SERIAL: NL&RAS-94-059

BRUNSWICK STEAM ELECTRIC PLANT, UNIT NOS. 1 AND 2
DOCKET NOS. 50-325 AND 50-324/LICENSE NOS. DPR-71 AND DPR-62
QUALITY ASSURANCE PROGRAM CHANGES

SUMMARY OF ORGANIZATIONAL AND FUNCTIONAL CHANGES

CHANGE DESCRIPTIONS REQUIRING NRC APPROVAL, INCLUDING REASONS/BASIS FOR CHANGE

Proposed Nuclear Services Department Organization

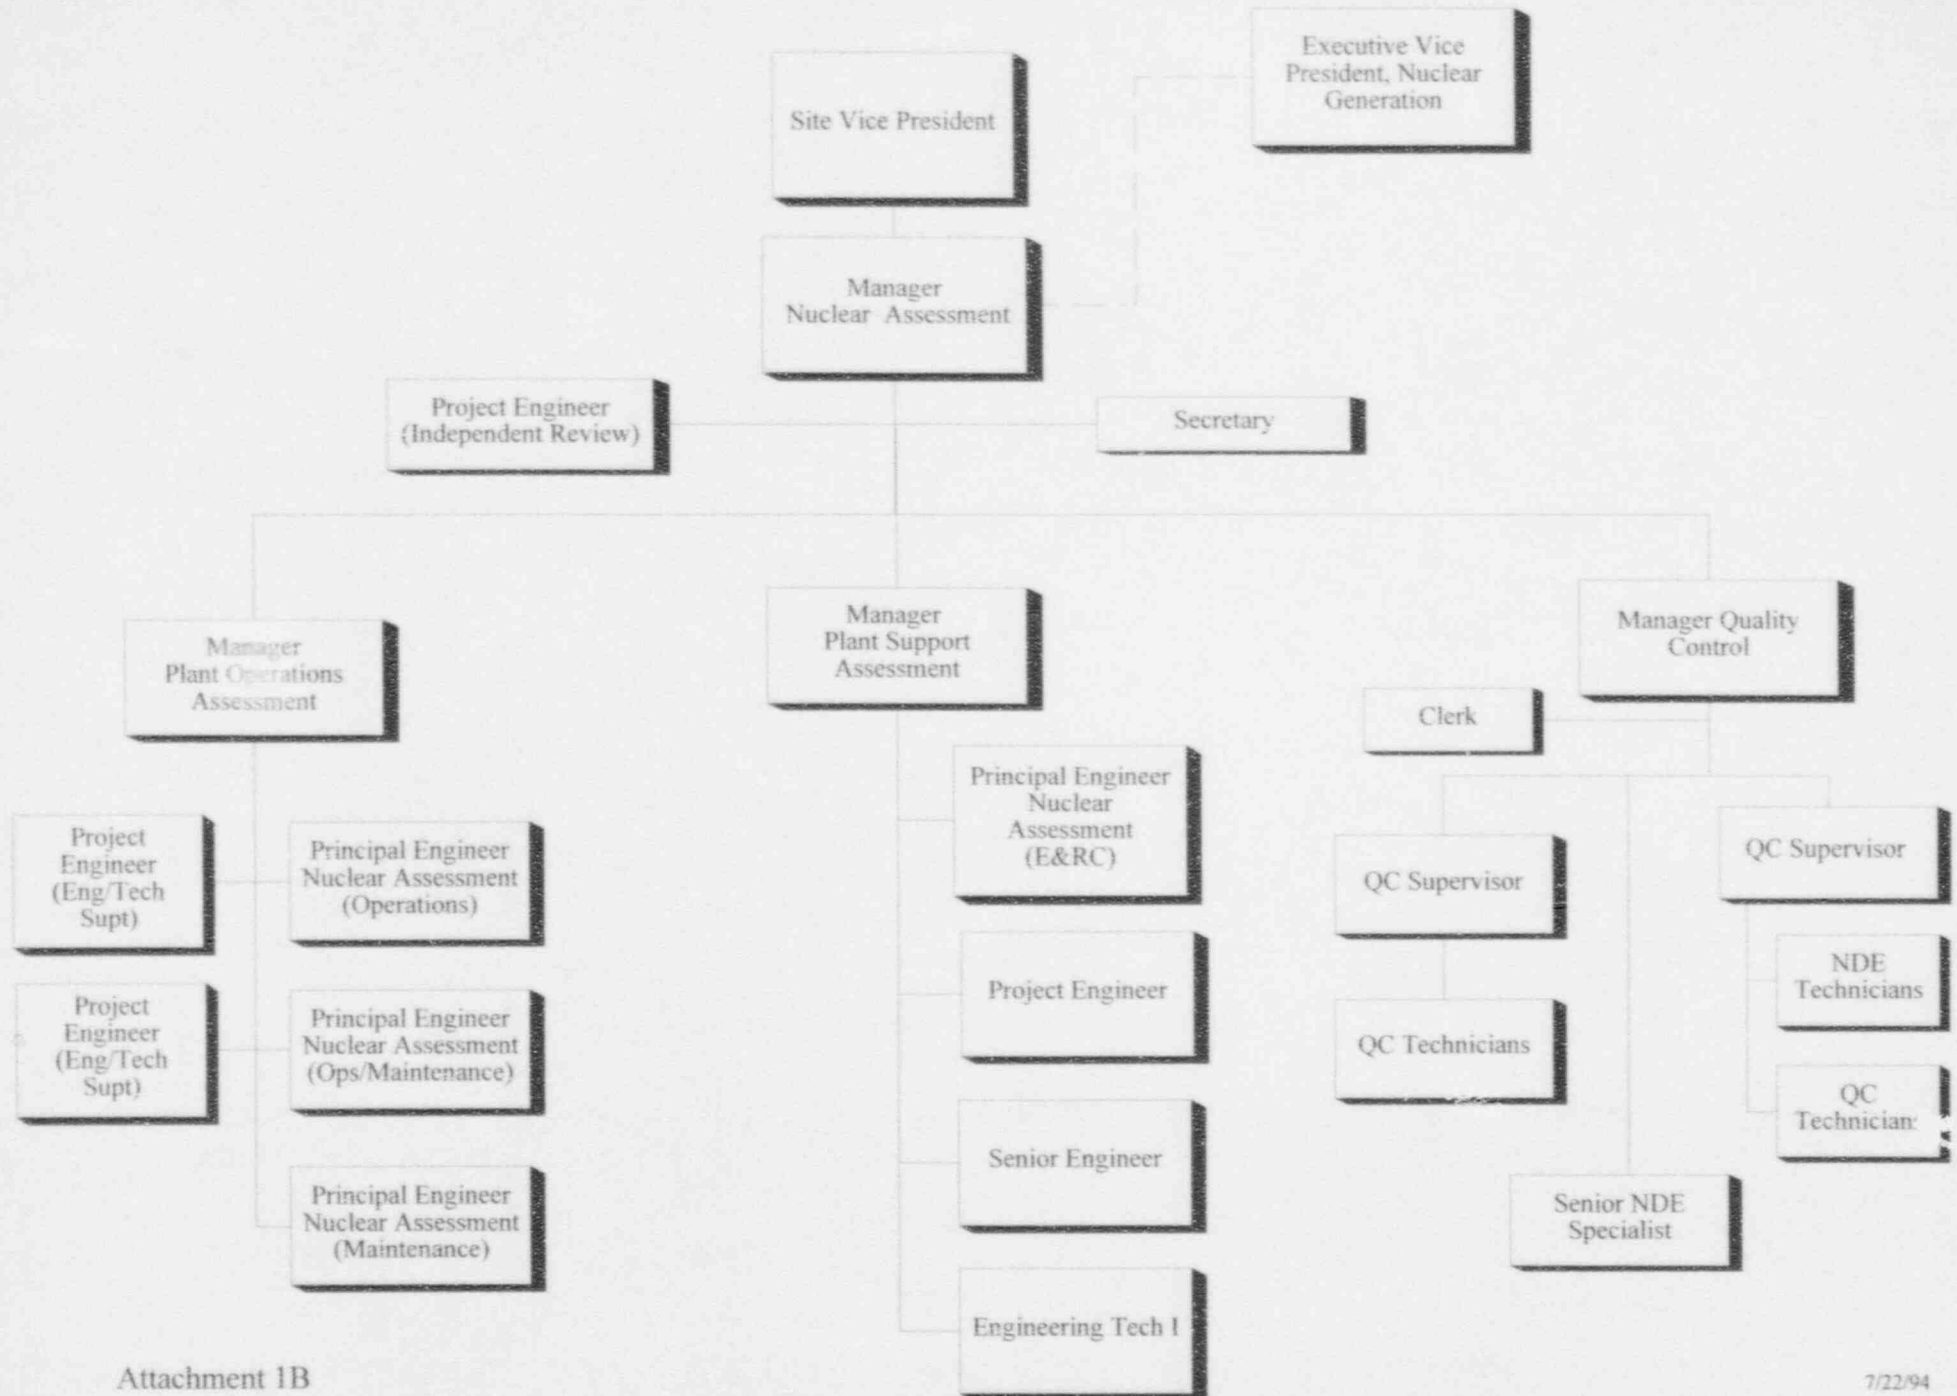
A Performance Evaluation Section (PES), reporting to the Vice President - Nuclear Services Department (NSD), will be established. The PES will provide a cadre of experienced assessment-trained, management-level, personnel to lead assessments and evaluate key areas of the plant and supporting organizations.

The proposed reorganization eliminates the NAD and realigns the plant NAS, reporting to the Site Vice President. The assignment of NAS as a direct report provides a valuable resource to the person held fully accountable for plant performance. The NAS will continue to conduct performance-based assessments to meet the 10 CFR 50, Appendix B, regulatory-required audits, and will assess to the Institute for Nuclear Power Operations (INPO) performance standards rather than minimum compliance standards.

The NAS Manager will report to the most senior CP&L manager on site, the Site Vice-President. This will ensure independence from the plant production organization. Other nuclear utilities have developed similar organizational arrangements for their quality assurance organizations.

The NAS has been aligned consistent with the current NRC Systematic Assessment of Licensee Performance (SALP) categories. The NAS organization is provided for your information in Attachment 1B. The responsibilities for the Plant Operations and Plant Support Units are discussed below:
